ORIGINATION FORM

Proposed Revisions to a Standard Plans Index
(Please provide all information – Incomplete forms will be returned)

Index Number: **18300**
Sheet Number (s): All
Index Title: Dynamic Message Sign Walk-In

CABINET LAYOUT 2

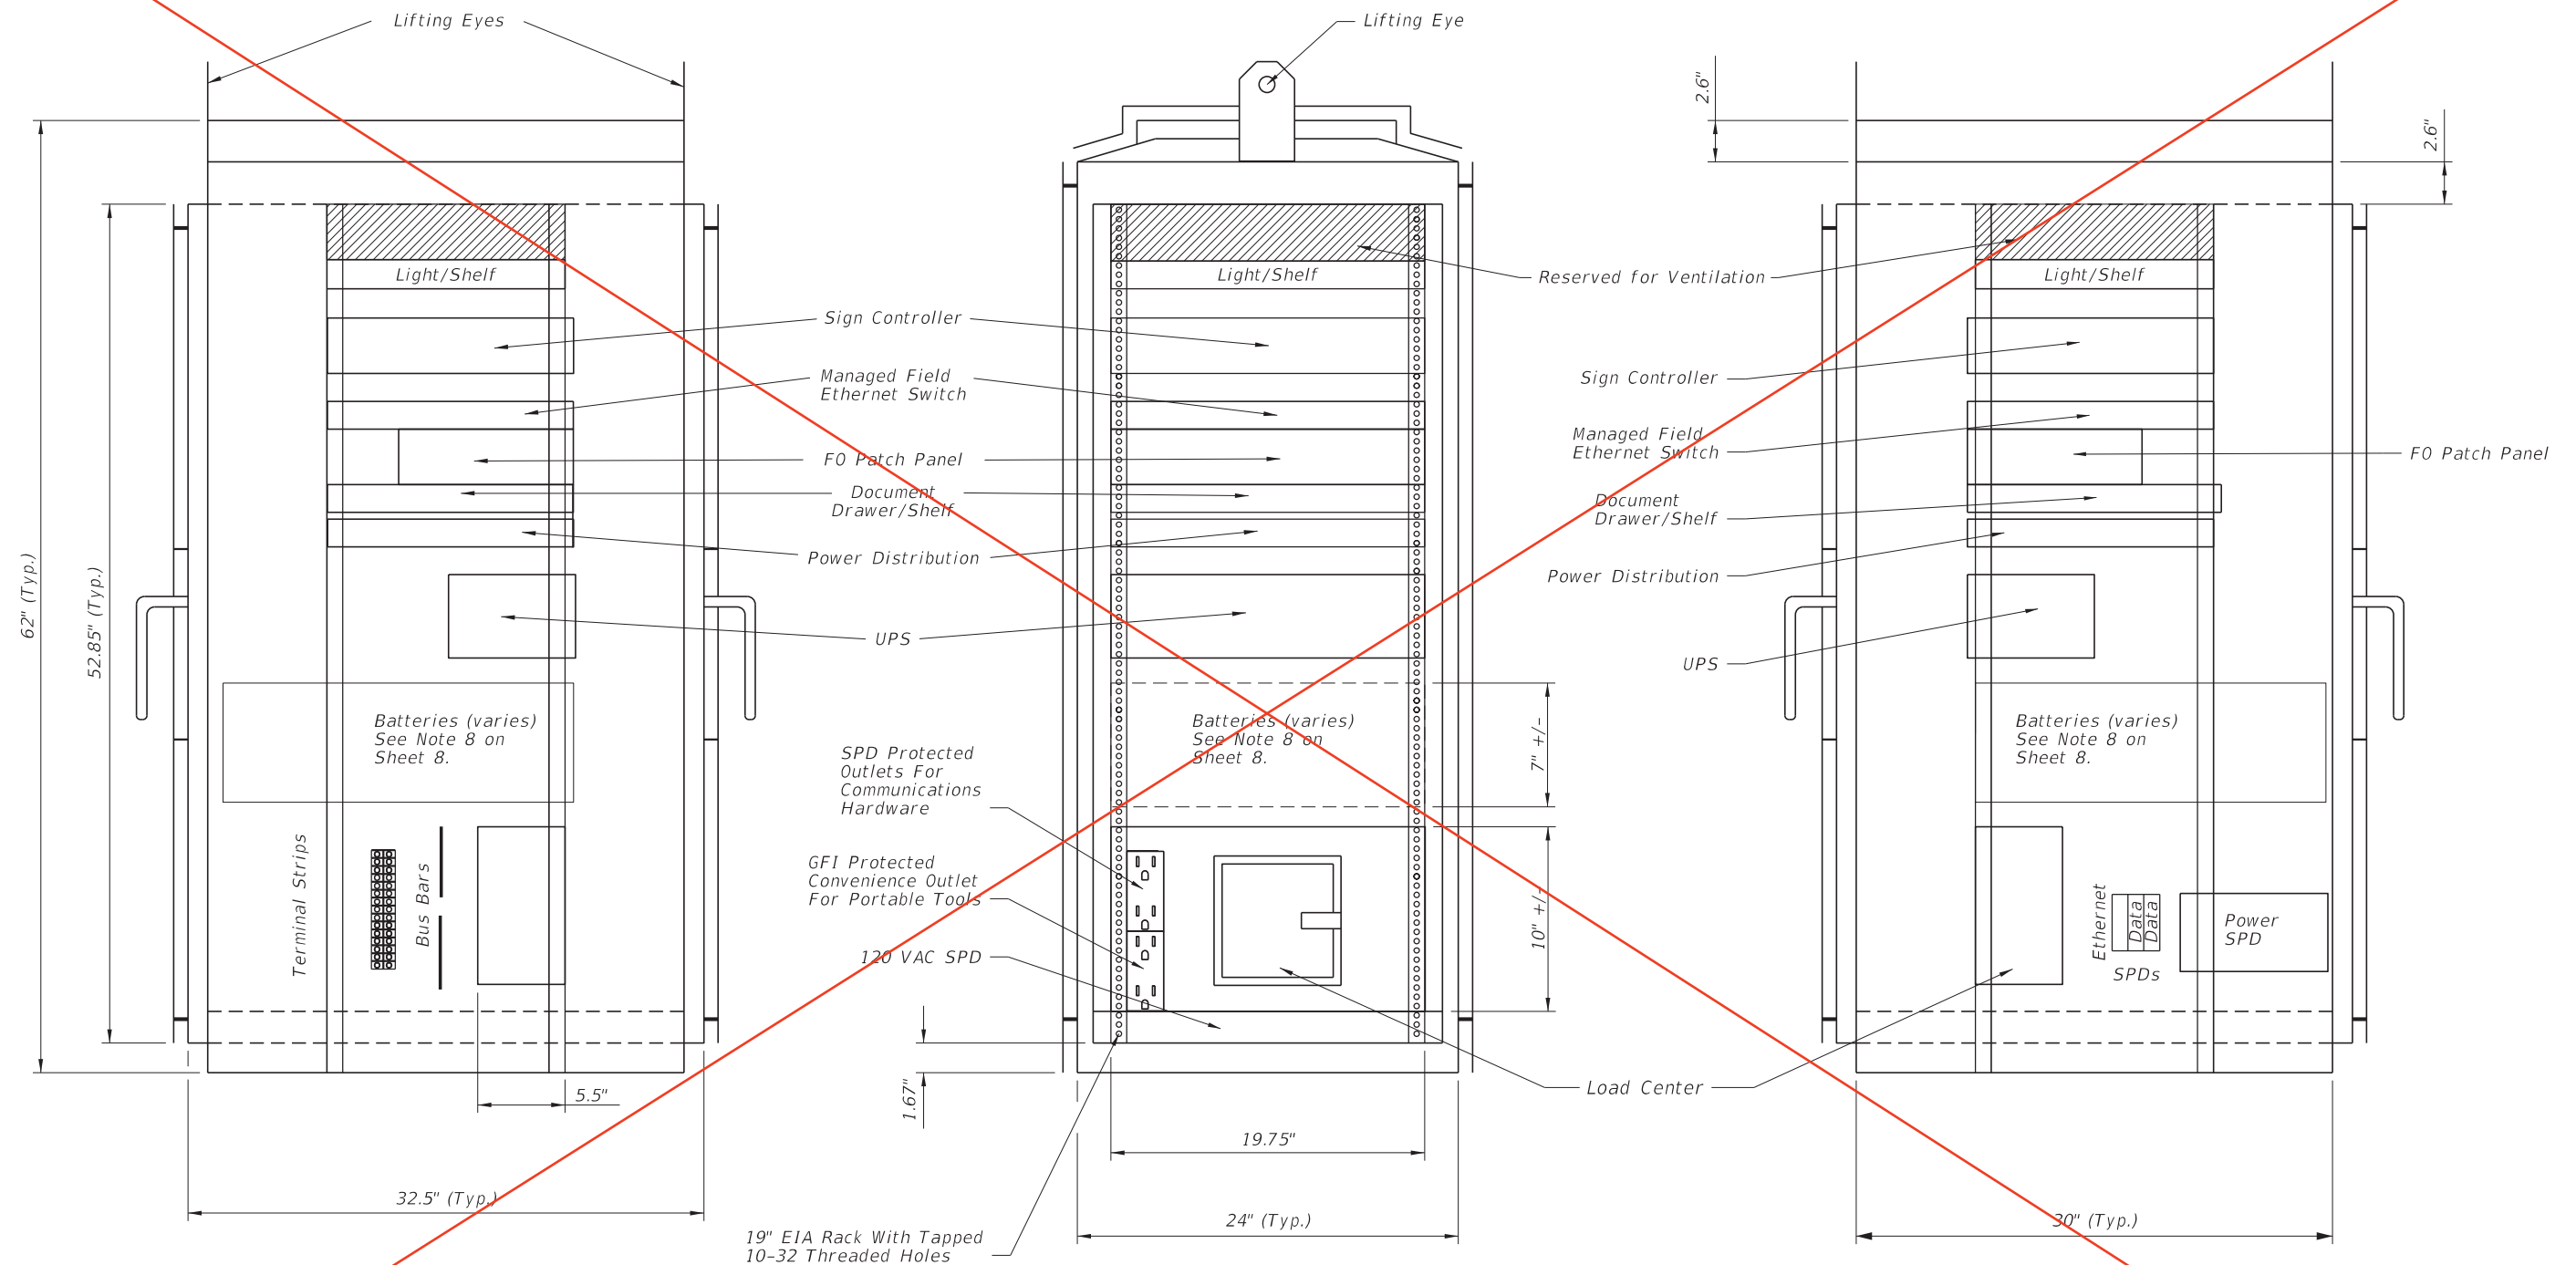
DELETED SHEET
